Technical Service Information

THM 4L60-E NO 3-4 SHIFT (6.2L DIESEL)

Figure 1

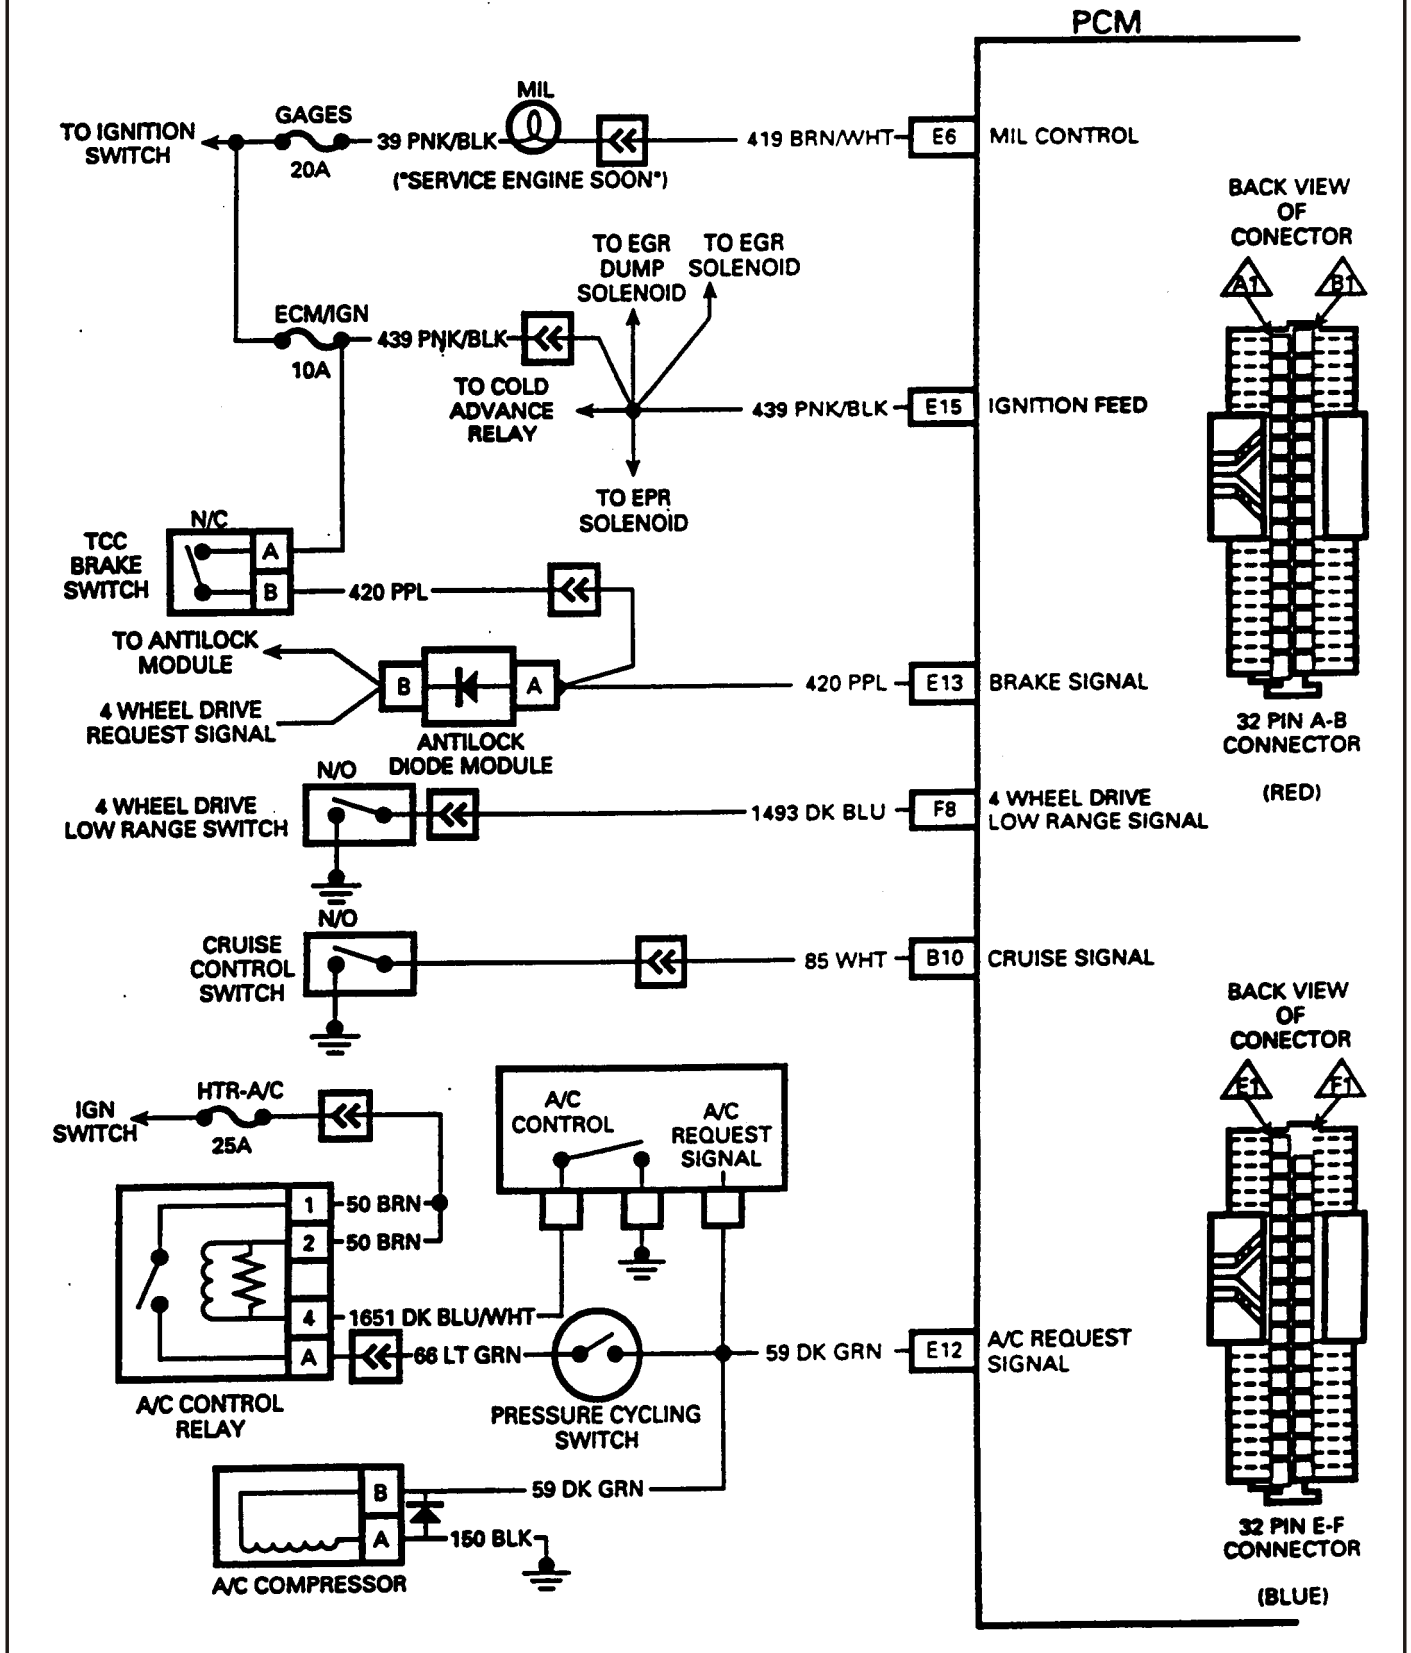
COMPLAINT: Some 1993 "C/K" Trucks and "G" Vans equipped with the 6.2L diesel engine and the THM 4L60-E transmission may not obtain 4th gear when the cruise control is engaged and vehicle speed is above 63 MPH. If the vehicle is in 4th gear at highway speeds with cruise control on and the transmission downshifts when going up a hill, or if the driver manually downshifts to drive and then back to overdrive, the transmission may not return to 4th gear.

CAUSE: If the vehicle is at highway speeds with cruise control on, and a 4-3 downshift is forced due to increased road grade (Engine Load). The vehicle then returns to stable or level road a 3-4 upshift may not occur, due to throttle position.

CORRECTION: Disconnect the white wire (Circuit 85) that runs from the cruise control switch to terminal B10 at the PCM. Refer to Figure 1 for C/K Truck wiring schematic, and Figure 2 for G Van wiring schematic. NOTE: The PCM uses this information to modify the shift schedules and TCC schedules when cruise control has been requested. If the white wire is disconnected the vehicle may exhibit a busy condition with the TCC.
